RotorSport UK Ltd

Service Bulletin

SB No.: 046 Iss1	CCAR No.: None	Classification:
Aircraft type & model (applicability) RotorSport UK Calidus	Aircraft serial Nos. effected RSUK/CALS/001-017	OPTIONAL or RECOMMENDED or MANDATORY

Photo below shows a 914UL installation. The 912ULS installation is similar.

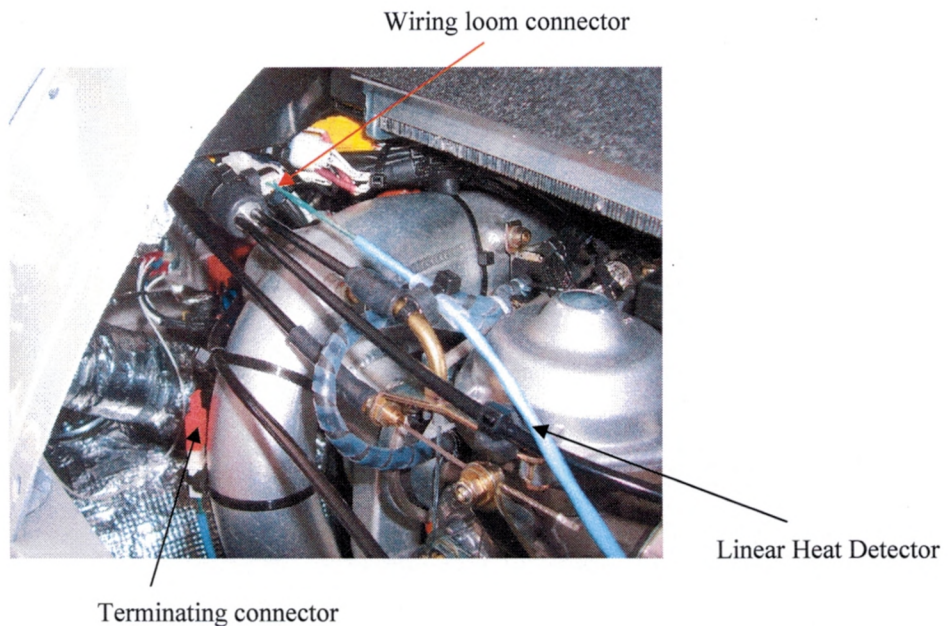
2. Identify the LHD terminations, one has the wiring loom connector, the other has the terminating connector
Cut the cable tie, remove the terminating connector and using special tool AMP 189727-1 extract the inserts from the opposite mating housing. This will enable lengths of silicone sleeving to be fitted over the LHD.

3. Count the number of retaining ties fitted to the LHD. Slide this number of sleeves RSD4653 over the LHD

4. Refit the connector pins, replace the terminating device and replace its retaining cable-tie.

Photo before modification

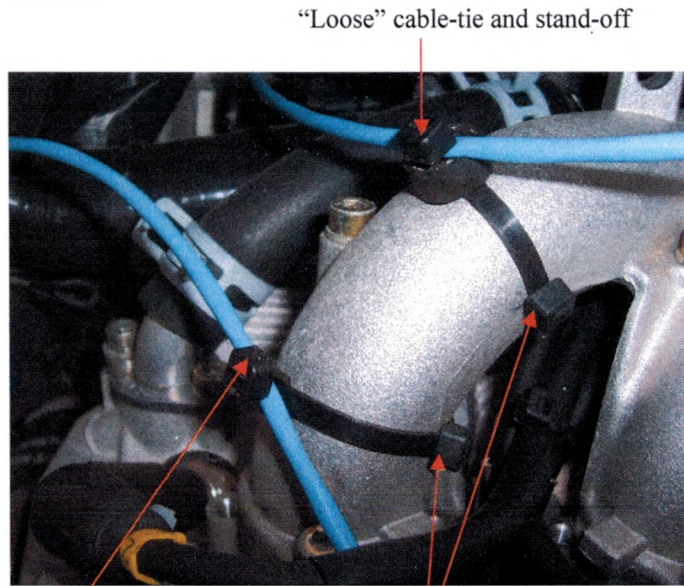
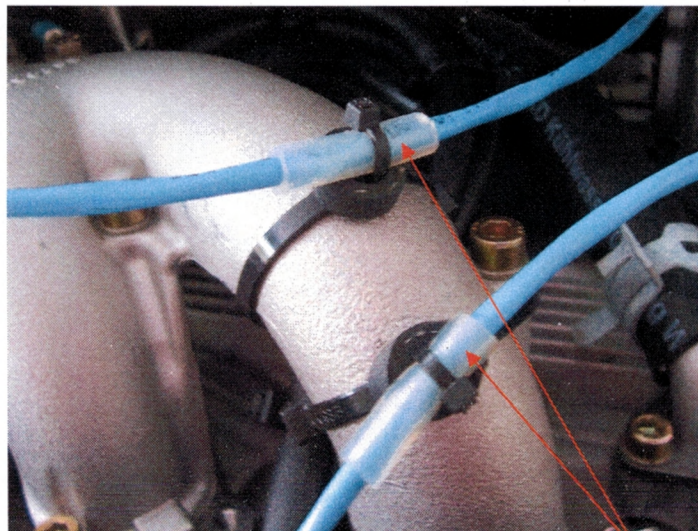
This cable is attached to a number of mounting points by means of nylon cable ties and/or stand-offs manufactured from short lengths of rubber hose. Although two ties are used at each mounting (one “loose” around the LHD and one “tight” around the fixing point) it is possible that a nuisance-trip could occur due to the LHD collapsing under the cable tie and making the electrical contact.

An improvement may be made to each mounting by fitting a short length of silicone sleeving under the “loose” cable-tie.

“Loose” cable-tie and stand-off

“Loose” cable-tie

“Tight” cable-ties

5. Progressively cut the “loose” cable-tie at each mounting position, move the sleeves past then fit the last sleeve at the mounting position using a new cable-tie. Tighten just enough to retain the sleeve without crushing.
(NB: This progressive sequence enables the routing of the LHD to be retained)

Photo after modification

Sleeves held firmly but not crushed
